ANADROMOUS WATERS CATALOG/ATLAS
CORRECTION FORM

ALASKA DEPT. OF
FISH & GAME
JAN 07 1998
REGION II
HABITAT AND RESTORATION

MAP: VALDEZ A-6

WATERWAY NUMBER: ALL TRIBS TO 221-60-11370.

CURRENT VERSION 1/95 WITH CHANGES TO 2226 & 2230 & TRIBS.

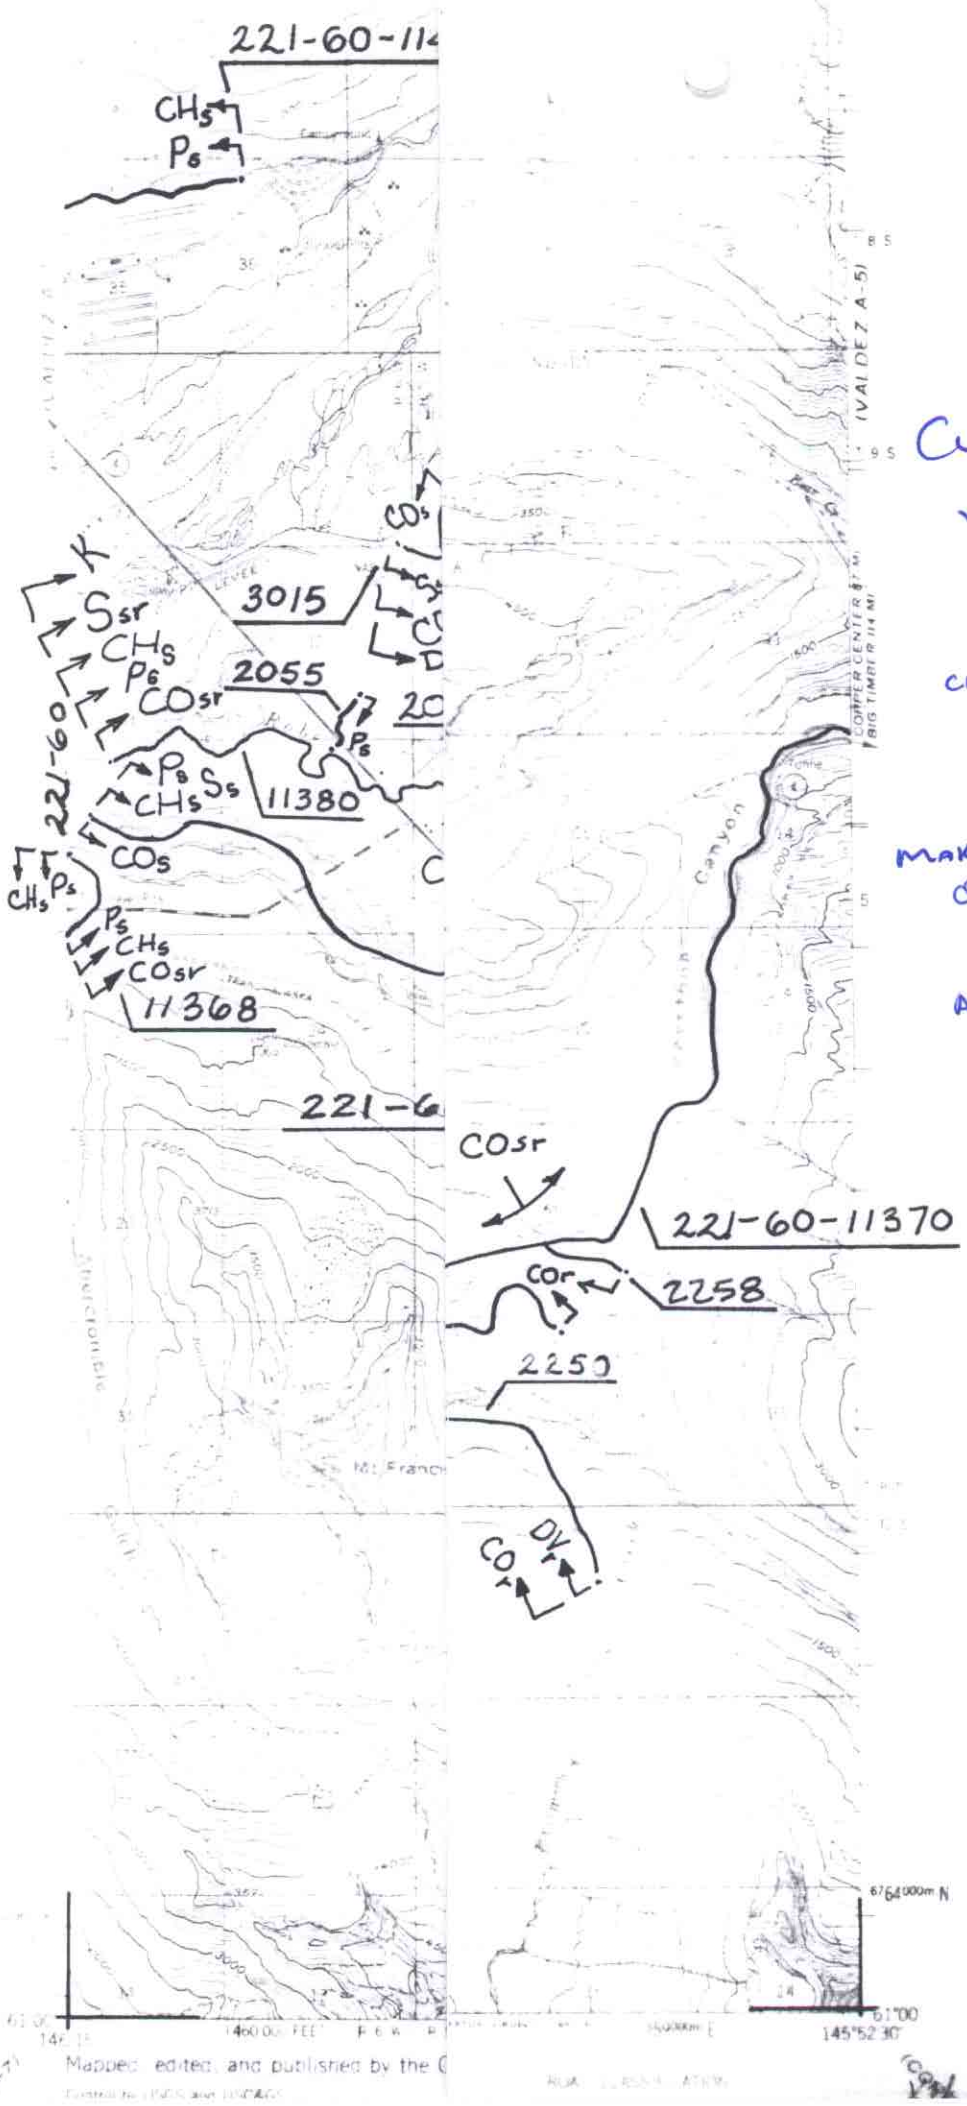
DESCRIBE CHANGE(S): REDRAFT STREAMS PER NEWER 1:25,000 SCALE MAPS. REDRAFT & SHORTEN 2250; REDRAFT 2254 & 2258 CHANGING CHANNEL COURSES & MOUTH POINT LOCATIONS; REDRAFT 2219 CHANGING MOUTHPOINT LOCATION; REDRAFT 2219-3015 & EXTEND PER OBSERVATIONS by A. GRATH; REDRAFT 2165 & 2165-3012 MOVING MOUTHPOINTS; REDRAFT 221-60-11380 CHANGING MOUTHPOINT LOCATION; CHANGE #.& REDRAFT STREAM # 221-60-11370-2219-3011 TO 2235
DELETE 221-60-11380-2099 (DISTRIB. of 2095) ADD ~~AS~~ CHANNEL ~~OF~~ 2095.

MAKE OTHER DRAFTING CHANGES PER ATTACHED PHOTOS & 1:25,000 MAPS.
